Appearance Change

Lead Frame Format Change of Select QFP Products in Amkor Philippines

Qualification Results Summary for QFP at AP1

Package	FROM: OMLF	TO: UDLF	Remarks
Top Package Appearance

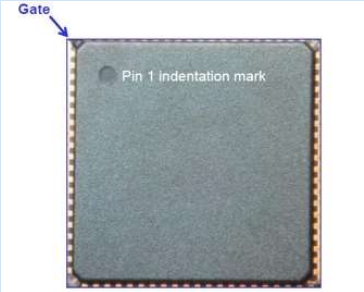
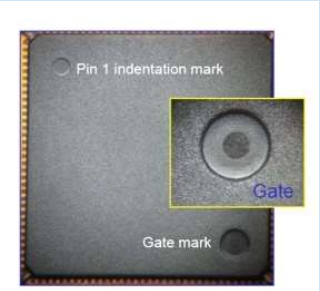
MATRIX BOTTOM CORNER GATE

UDLF TOP CORNER PIN GATE	OMLF: Corner mold gate UDLF: Top mold gate Package Dimensions: No change
Bottom Package Appearance
